COMMENT LETTER 142

RESPONSE TO LETTER 142

Gold Line Phase II – Pasadena to Montclair
Draft Environmental Impact Statement / Environmental Impact Report

Attachment #1 (P. C-212 from Volume III – conceptual engineering drawings. Plan modified to graphically represent requested analysis of sound wall mitigation alternative)

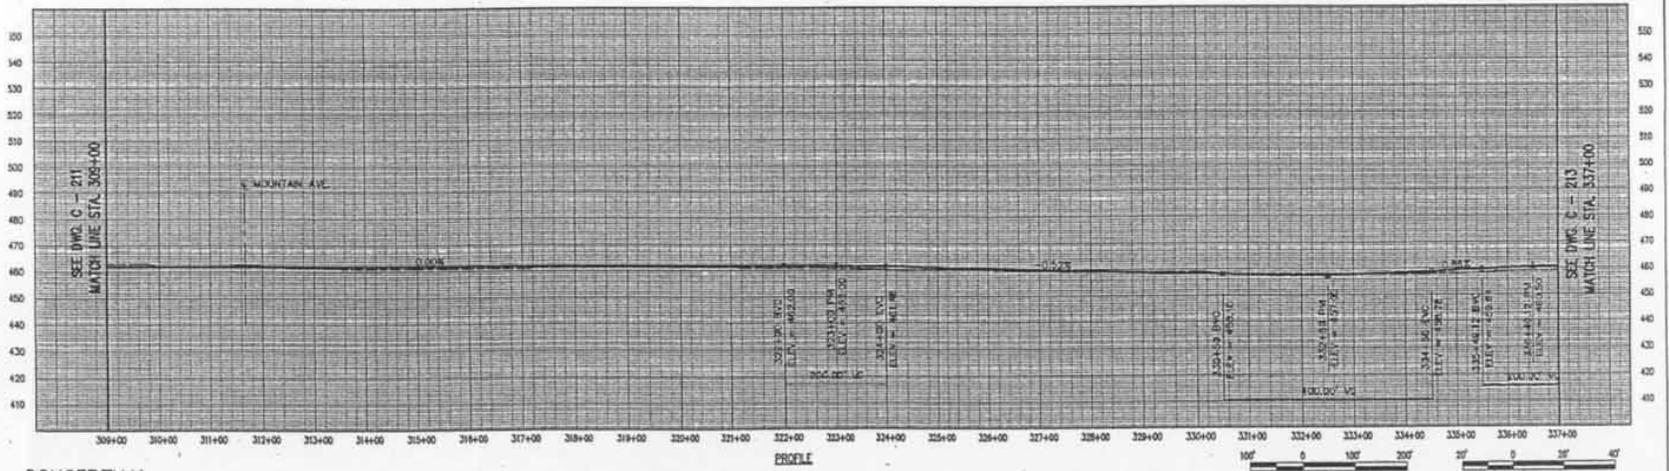
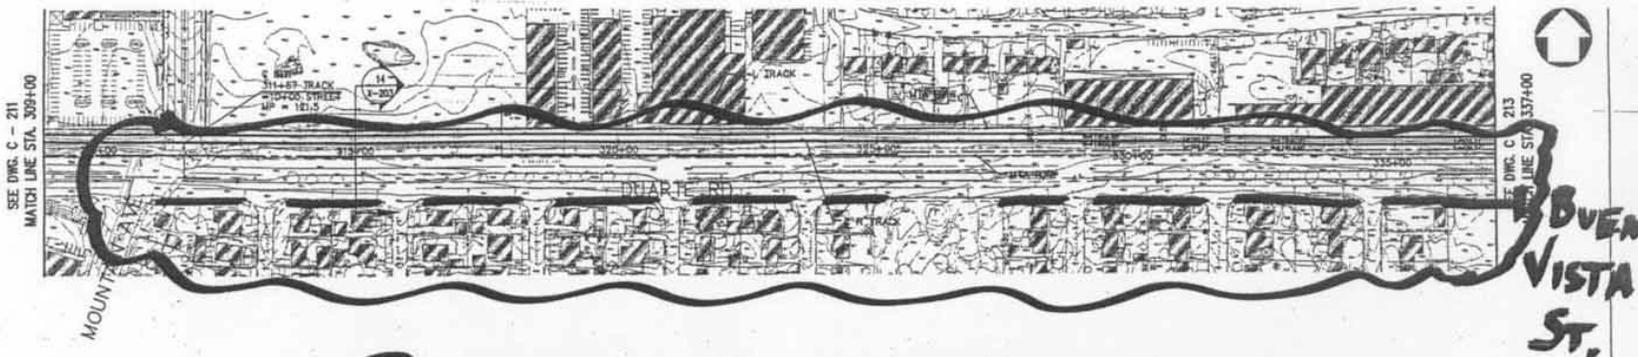
PROPOSED SOUND WALL ALTV.
